Comments: June 13, 2025

Responses: July 9, 2025

**Subject: Feedback Form – Completeness Review
Site Plan Control Application and Plan of Condominium Application
615 Mikinak Road**

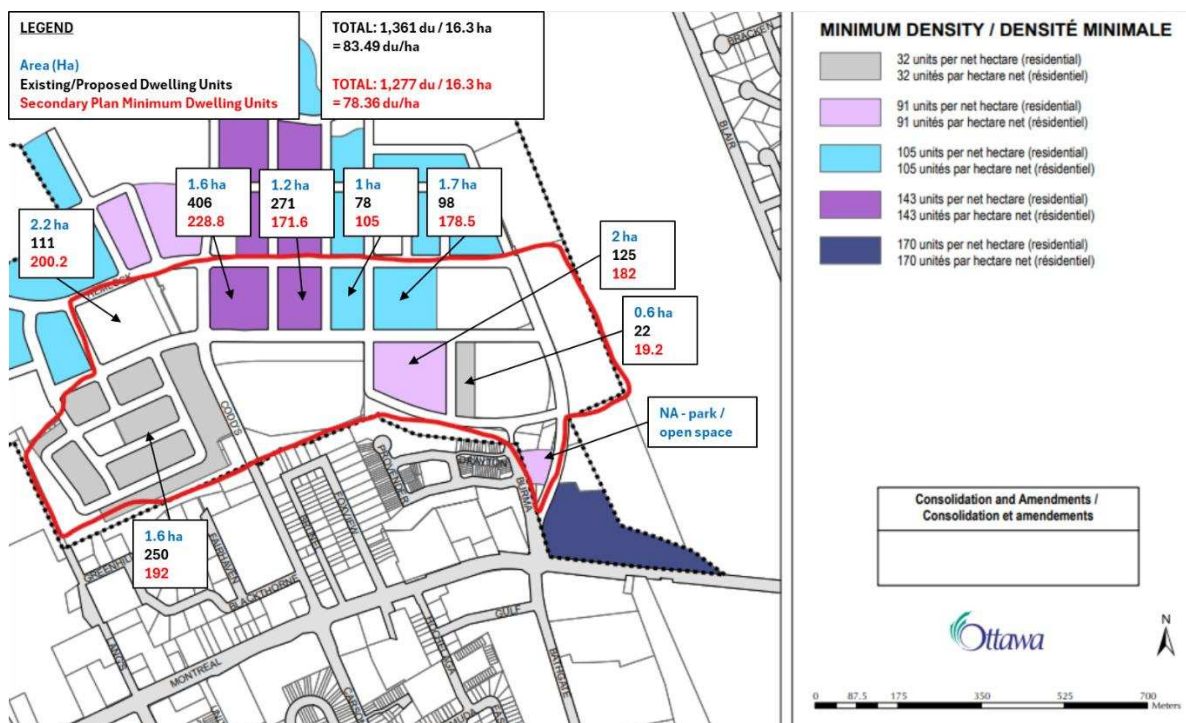
1. As per the Secondary Plan, a density of 91 units per hectare is contemplated on the subject lands, where the school board decides not to exercise its right to purchase a school block. Please provide rationale as to how the proposed development meets the densification targets of the policy framework, such as how Phase 1A achieves the density targets of the Secondary Plan. Zoning relief to permit the proposed development will need to demonstrate consistency with the policy framework.

Response: In the pre-consult feedback form the City stated the below:

“Required density is 91 units per hectare. That said, we interpret the Secondary Plan density targets applying at a broader scale to the phase of the subdivision, typically supported by a Master Concept Plan. I would ask that you examine the whole of Phase 1 (boundaries identified in the following screen capture) to ensure that we are achieving the density envisioned for this phase of development.”

The below analysis reflects the area identified in the above City comment from the pre-consult. The existing/proposed density exceeds the minimum density requirement by 5 dwelling units per hectare, which equates to 84 total units over the area of the phase identified by the City in the screen capture).

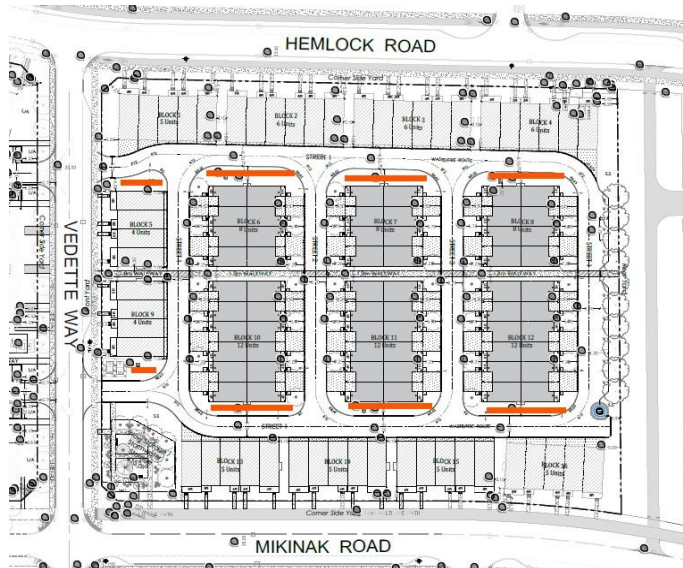
2. Tree Planting: Staff recommend increased tree planning along interior and

boundary streets. In particular:

- a) Can the landscaped areas south of Blocks, 10, 11, and 12 and north of Blocks 6, 7, and 8 support the planting of new trees based on the recommendations of the Geotechnical Report's findings? Can a deep, lean, concrete foundation be implemented, in order to reduce the required setbacks from the trees to the foundation?

Response: With sensitive marine clay soils present on site, we are required to maintain 4.5m foundation offsets. With required 1.5m curb offsets, trees are unable to be installed adjacent to Block 6, 7, 8, 10, 11, 12. There are also underground servicing conflicts at all noted areas further limiting tree planting, regardless of the foundation design.

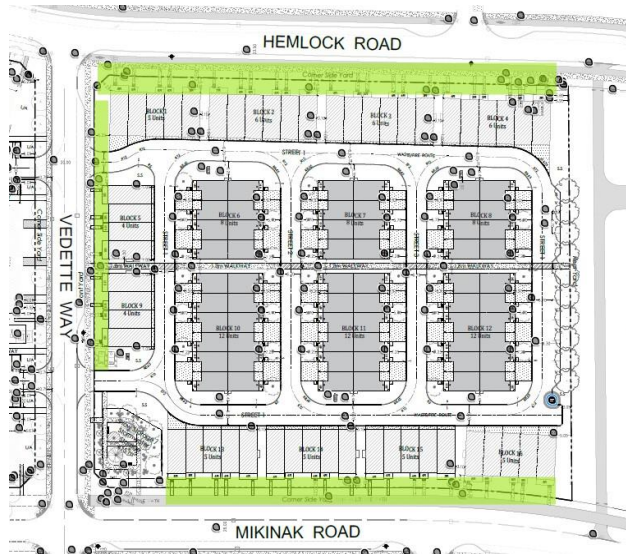
- b) No substantial tree planting is indicated along any of the boundary streets, being Hemlock Road, Vedette Way, and Mikinak Road.
 - i. Staff encourage planting street trees within the landscaped areas along all three boundary streets indicated above.

Response: Street trees along all boundary streets are existing, and part of streetscape works by Canada Lands Company (CLC). All existing trees in these areas will be reviewed against our landscape plans through detailed design and construction, and relocated as required.

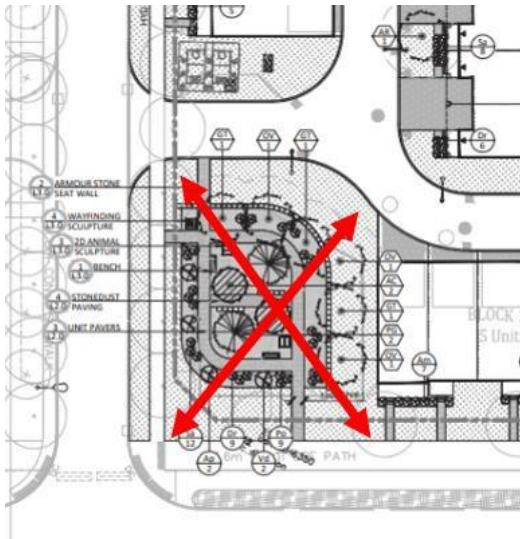
23. The interface between the park and development should be improved. Would it be possible to remove the fence to explore additional connections from the site to the park as well as opportunities for additional tree planting and landscaping?

Response: The fence is understood to be City-owned and so we defer the comment back to the City for internal coordination. From Mattamy's perspective they are agreeable if the City wishes to remove the fence.
